**HUMBOLDT COUNTY RESOURCE CONSERVATION DISTRICT
ADDENDUM #1**

RELEASE DATE: May 25, 2021

PROJECT TITLE: “East Garberville Shaded Fuel Break Mastication”

East Garberville Shaded Fuel Break - Treatment Units

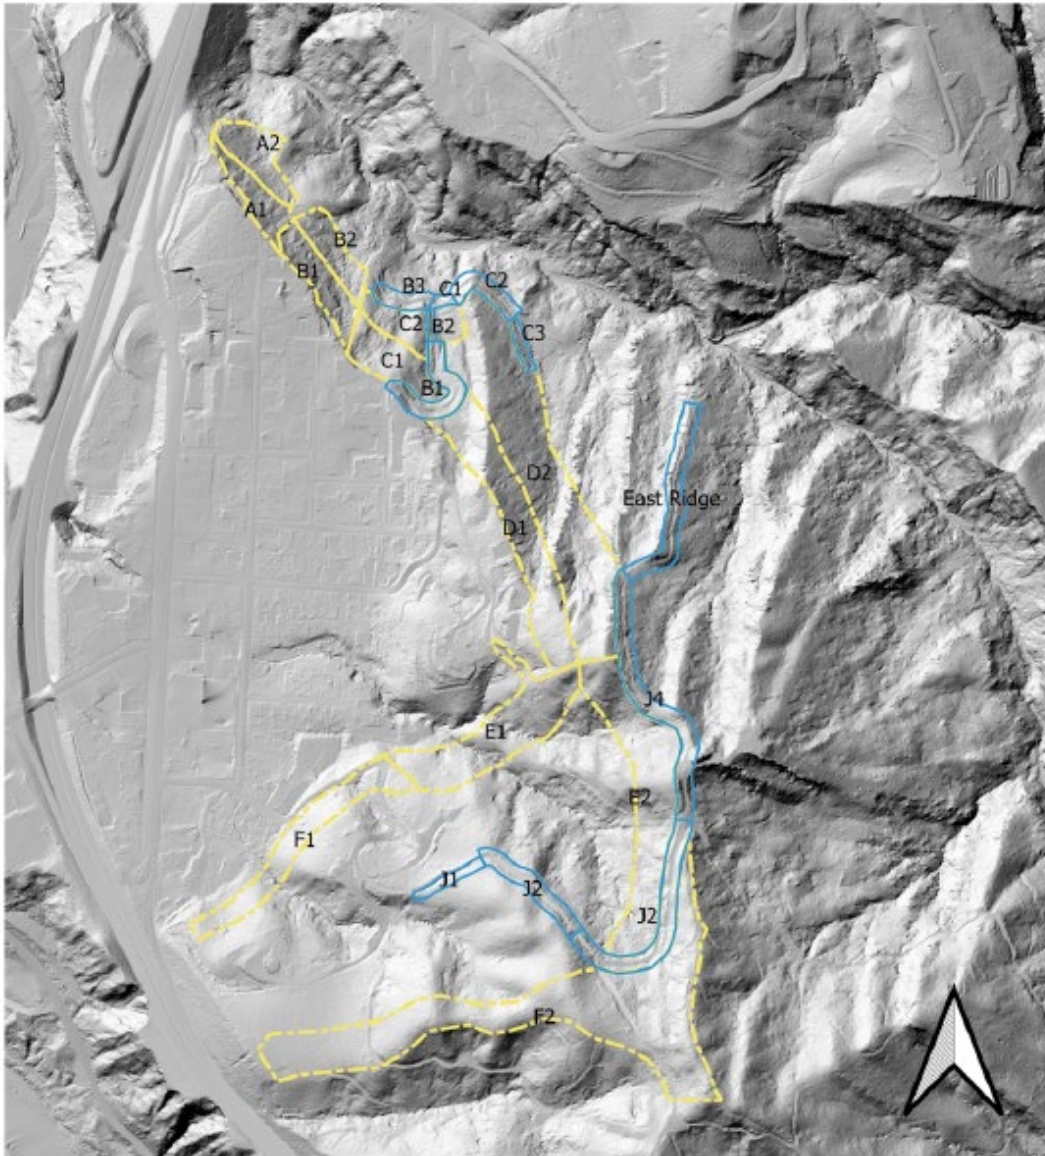
16. How was the project identified and how does the mastication work fit into the larger project?

The project was initially conceptualized by the Southern Humboldt Fire Safe Council and CAL FIRE. The mastication work described here is part of a larger 40 acre fuel break along the east side of the town of Garberville, CA. A map of the treatments is provided on the next page (please note, masticator units B1/B2/B3 and C1/C2/C3 are not part of this RFP). For more information about this and other Humboldt County fire prevention projects, please visit the 2019 Humboldt County Community Wildfire Protection Plan at <https://humboldt.gov/2431/CWPP-2019>.
